Product Change Notification

Date Issued :	May 27, 2022	PCN Number :	512108
Reason for Change :	Obsolete		
Description of Change :	This notification is to inform you about the Obsolescence of parts(s) referenced in this notice. Please connect with your Molex Sales Engineer for additional queries related to possible replacement part(s).		
Reason for Short Notice :	Force Majeure		
Planned Implementation Date :	September 20, 2022		
Recommended replacement parts :	Please see the attached replacement parts list .xls file.		
Last Time Buy Date for Obsolete Parts :	June 20, 2022		
Last Time Ship Date for Obsolete Parts :	September 20, 2022

SFP+/ZSFP+ Ganged Cage

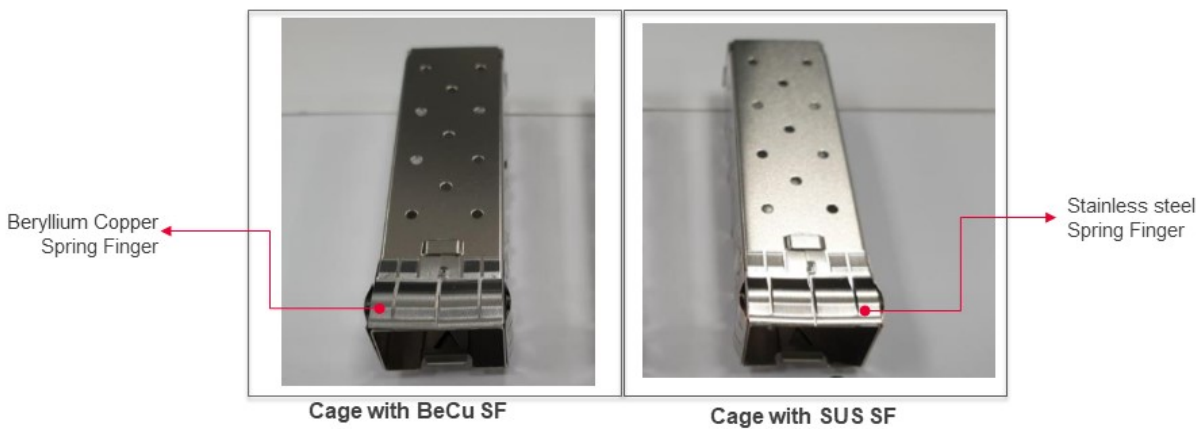
- Please be advised that the following Part numbers from the SFP+/ZSFP+ Ganged cages product families are being made Obsolete with replacement. The spring fingers of the offered replacement parts will be made of Stainless Steel.

- Product Impact
 - No impact to fit ,form or function based on test summary 747548001 (available upon request).

- Reason for Change
 - Critical shortage of Beryllium Copper which is the raw material used in spring fingers of the affected parts.
